**SUBJECT:** **NEW VEHICLE DEMONSTRATION / DELIVERY HOLD**

**Safety Recall 25S52 – Supplement #2**

Certain 2023-2025 Model Year Escape and Corsair, 2024-2025 Model Year Nautilus, 2025-2026 Model Year Bronco Sport and 2025 Model Year Maverick Vehicles Equipped with an Engine Block Heater System  
Block Heater Replacement

**FIGURE 1**

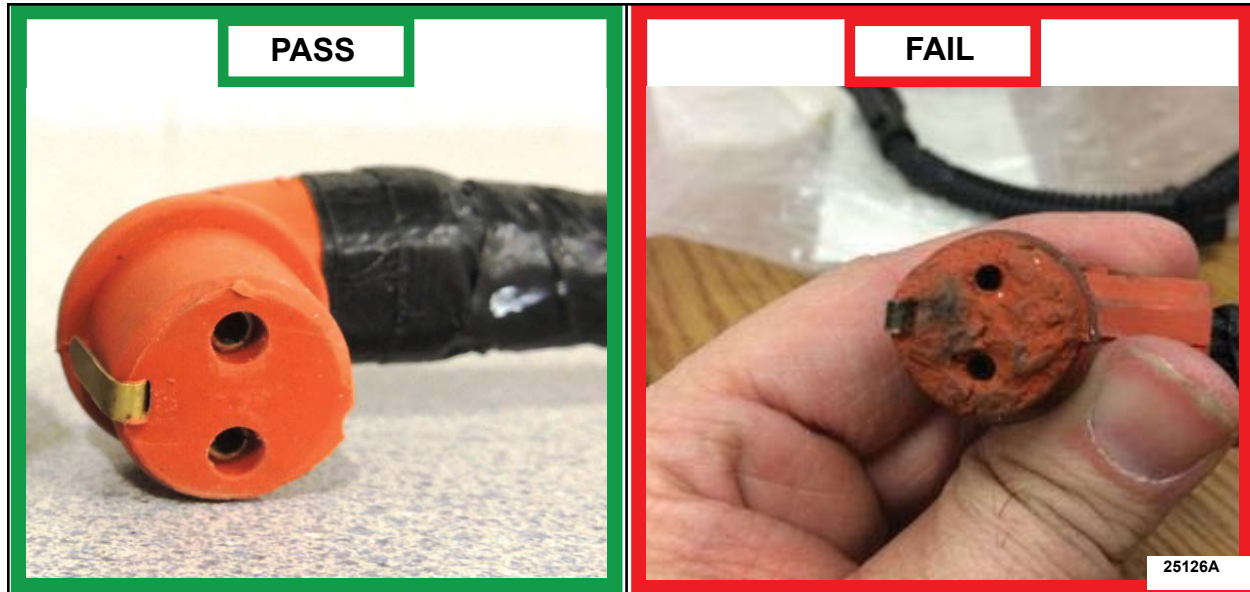
2. Inspect the engine block heater power cable for the following concerns. See Figure 1.

- Were any of the concerns below present on the engine block heater power cable?
  - Connector damage (e.g., cracked, charred and/or degraded silicone).
  - Presence of moisture or coolant contamination.
  - Oxidized or corroded terminals.
  - External cable insulation damage (e.g., cuts, abrasions, and/or pinched areas).
  - Evidence of thermal deformation (melted insulation).
  - Damaged or missing wiring retainers (verify integrity and replace as needed).

- The cable has failed.
- Order a new engine block heater power cable through normal order processing channels. Special Service Support Center (SSSC) approval not required.
- Proceed to Step 4.

3. Perform a continuity and resistance test using a digital multimeter to identify internal opens or shorts. Was resistance greater than 1 ohm?

**NOTE:** If the power cable is replaced, claim as related damage on a separate repair line from the FSA. See the Dealer Bulletin for details.
